Access Compliance Report

Public Rights-of-Way

(Curb Ramps)

Intersection ID: 12278	Main Street: SEIGLE_AV	Cross Street: VAN_EVERY_ST	Location: E
ADA ID: A2E15319BFDF	Ramp Type: Perp	Initial Pass/Fail: Fail	Overall Compliance: No
Severity Score: 13.75			
Codes/Mitigation Info/Possible Solution		Field Measurements/Component Compliance

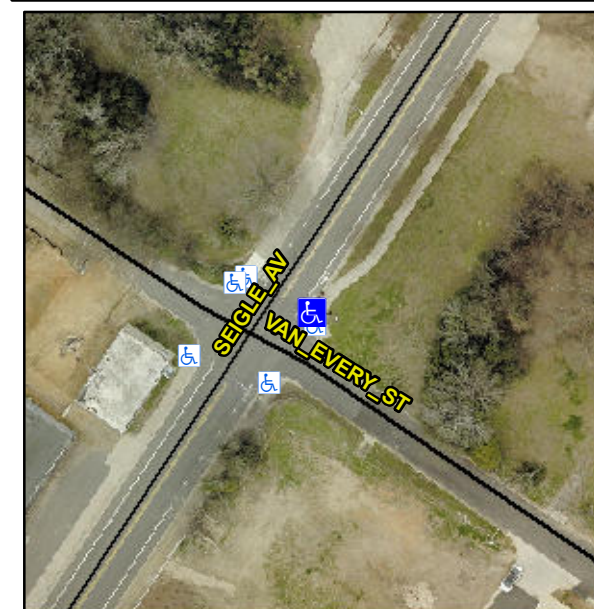
Not Found, R304.2.2

Compliance	Description	Data	Compliance	Description	Data
N/A	Ramp Length (in)	74.0	No	Ramp Slope (%)	9.9
Yes	Ramp Width (in)	59.0	Yes	Ramp XSlope (%)	2.4
N/A	Flare Type LT	N/A	N/A	Flare Type RT	N/A
N/A	Flare Slope LT (%)	N/A	N/A	Flare Slope RT (%)	N/A
N/A	Flare Traversable LT?	N/A	N/A	Flare Traversable RT?	N/A
N/A	Landing Length (in)	N/A	N/A	DWS Provided?	N/A
N/A	Landing Width (in)	N/A	N/A	DWS Contrast?	N/A
N/A	Landing Slope (%)	N/A	N/A	DWS Length (in)	N/A
N/A	Landing X Slope (%)	N/A	N/A	DWS Full Width?	N/A
N/A	Landing Curb? (Y/N)	N/A	N/A	DWS Offset (in)	N/A
N/A	Shared Landing?	N/A			
N/A	Gutter Ponding?	N/A	N/A	Gutter Slope (%)	N/A
N/A	Gutter Lip Ht (in)	N/A	N/A	Gutter X Slope (%)	N/A
N/A	Painted X Walk1?	No	N/A	Painted X Walk2?	N/A
	X Walk 1 Direction	To NW		X Walk 2 Direction	N/A
N/A	X Walk 1 Width (in)	N/A	N/A	X Walk 2 Width (in)	N/A
	X Walk 1 Slope (%)	1.5		X Walk 2 Slope (%)	N/A
	X Walk 1 X Slope (%)	5.0		X Walk 2 X Slope (%)	N/A

Remove & Replace Entire Ramp.
